**Subject:** Eagle Rising SF2225 Plat Filing 1 Response Letter and EDARP Upload

Our responses to the EPC November 2024 Plat and related documents review comments have been uploaded EDARP.

**Extract from Engineering Criteria Manual**  
5.4.2. Driveway Permit Required

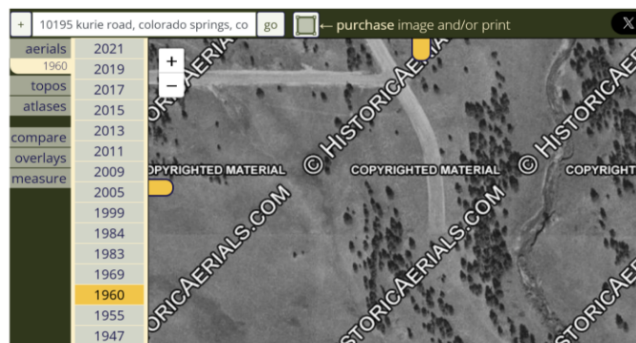
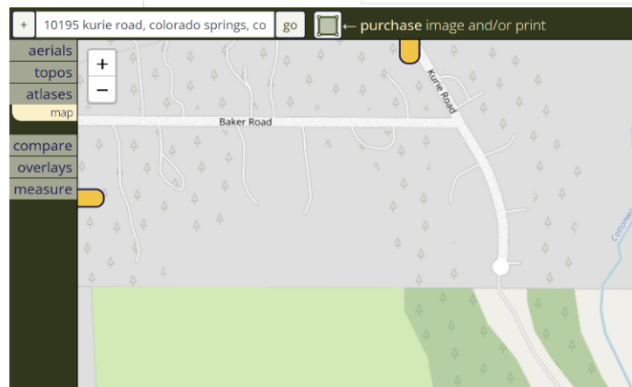
Regarding the unjustified request for a new driveway permit for 10195 Kurie Road property, please consider that the EPC Engineering Criteria Manual (ECM), only requires a permit for an existing driveway that will be changed or there is a change in use. Furthermore, a Driveway Permit is a temporary instrument issued for only 90 days.

The ECM Section 5.4.2 Driveway Permit Required screenshot below is for driveways to be constructed, reconstructed, paved, altered or change in use, or for culvert work, and as noted above the ECM 5.4.7 screenshot below says a driveway permit will expire if a building permit is not obtained within 90 days.

After we evaluated ECM 5.4.2 and 5.4.7 and considering that no change to the existing driveway or no new construction, and no change in use to the principal residence or detached garage, common sense must prevail. Therefore, we do not believe that a new driveway permit for 10195 Kurie Road will be

required nor will an application be submitted for the Eagle Rising Filing 1 Final Plat. We trust that you agree.
